Response to Request for Additional Information – ANP-10287P
“Incore Trip Setpoint and Transient Methodology for U.S. EPR Topical Report”
(TAC No. Q00013)

Figure RAI 13-1: GKN1 Cycle 26 Map 32 Calculated vs. Measured F_{dh} Distribution

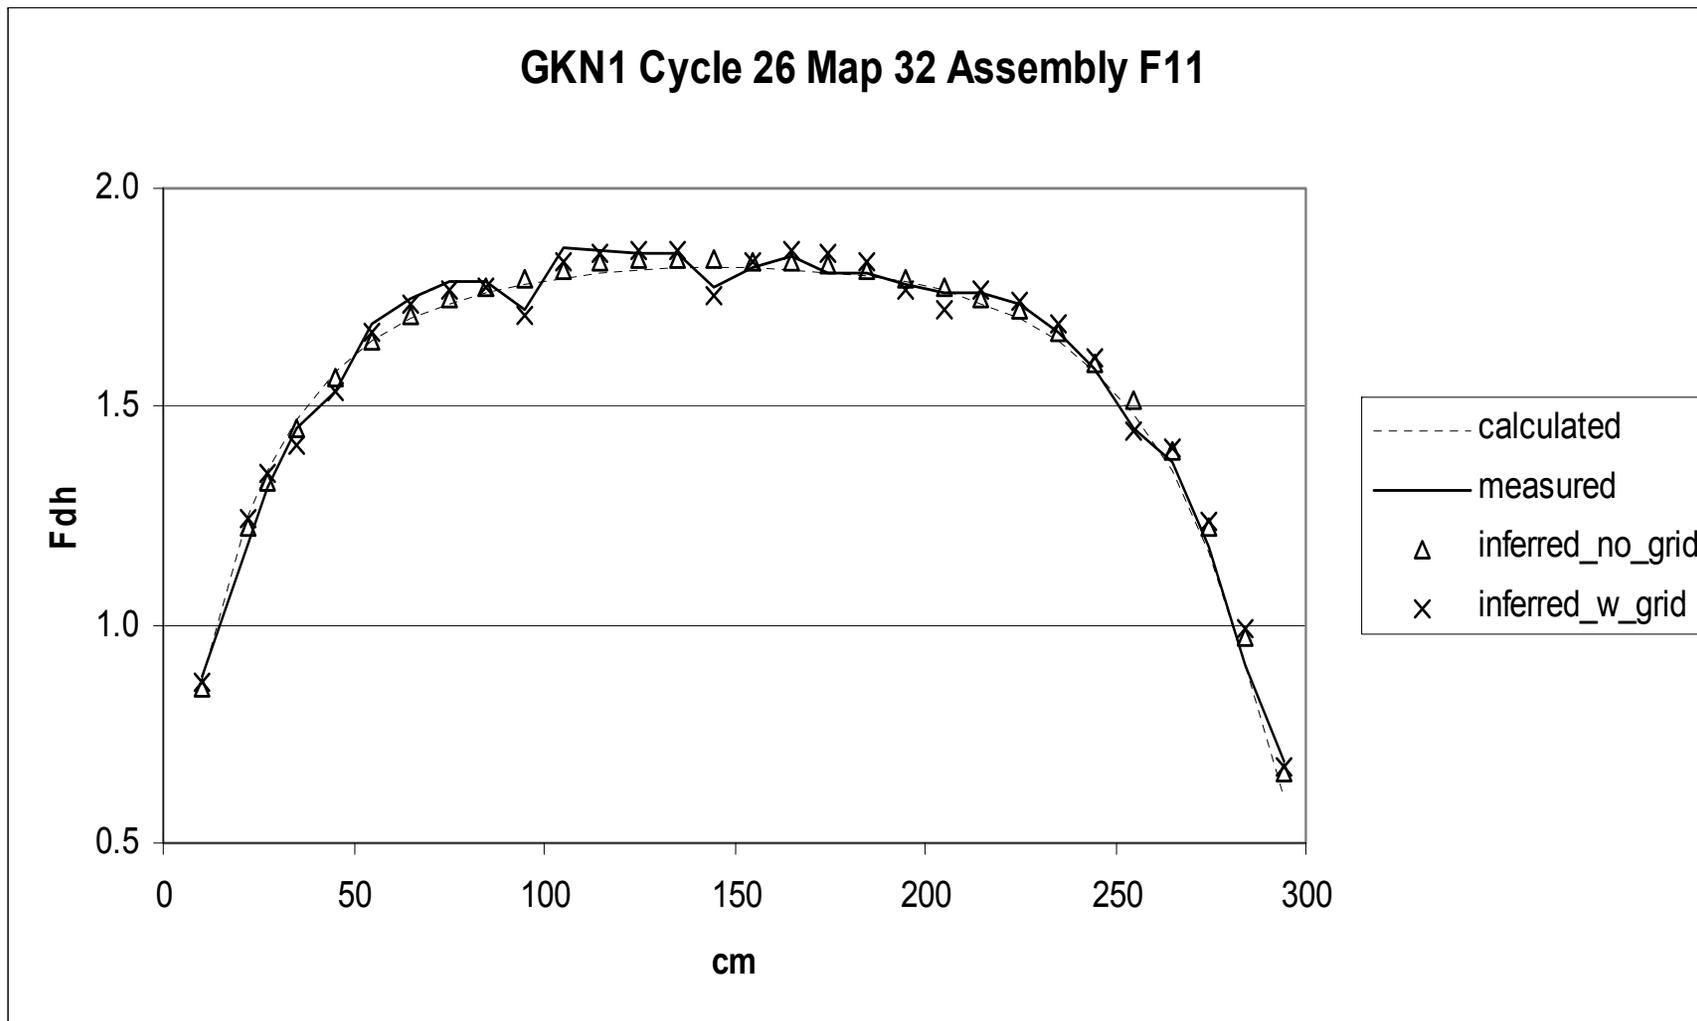
RAI-13. *Describe in physical terms the MEDIAN methodology used to extrapolate the adjusted fluxes to the non-measured nodes (Section E4 of ANP-10287). Provide an example calculation with the actual numbers for an AMS measurement.*

As an example of the application of the MEDIAN methodology, GKN1 Cycle 26 Map 32 (cycle burnup = 1.66 GWd/MTU) will be used. Figure RAI 13-1 presents the calculated versus measured 2D F_{dh} results for this map.

Figure RAI 14-2: GKN2 Assembly Type 1 Conversion Factor Sensitivity to Instrumented Location

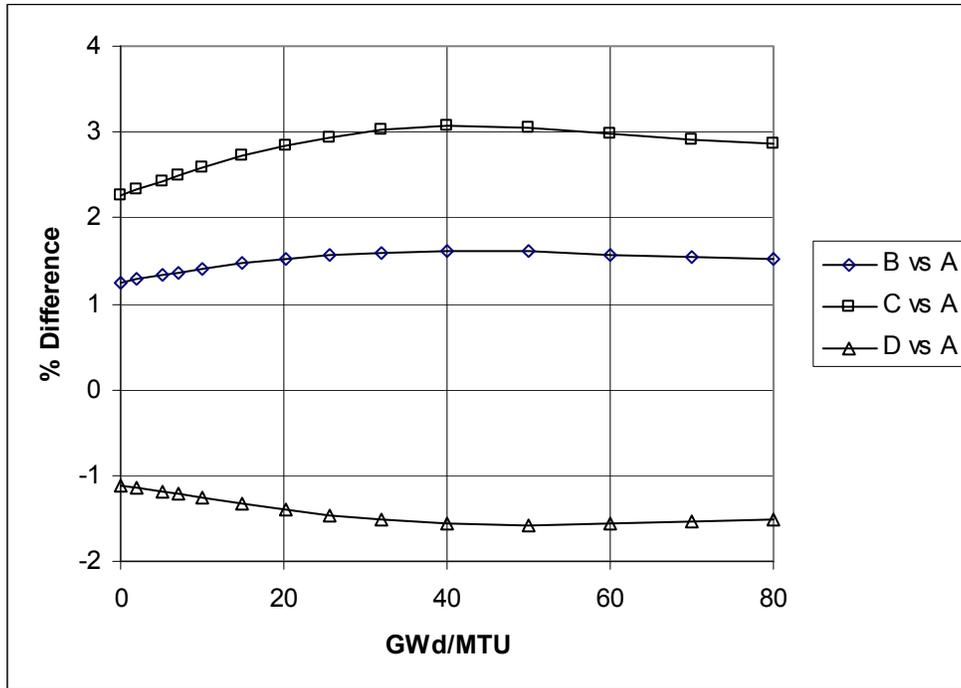
RAI-14. *Provide measured data to support local peaking factor uncertainty discussed in Section E.7.4 of ANP-10287 over the relevant range of exposures where a fuel pin would be limiting.*

- The first assembly type was a non-gad assembly with 3.80 without U235 enrichment. The percent differences between the calibration factor results are presented in Figure RAI 14-2.
- The second assembly was a gad assembly with 3.80 without U235 enrichment and twelve pins of seven without gad at 2.60 without U235 enrichment. The gad rod locations are shown in Figure RAI 14-1. For locations C and D in the gad assembly, gad rods are located diagonally adjacent to the instrumented location. The results are presented in Figure RAI 14-3.

Figure RAI 14-2 shows a spread of over 4% is observed for the non-gad assembly, and Figure RAI 14-3 shows a similar spread after the gadolinia burns out.
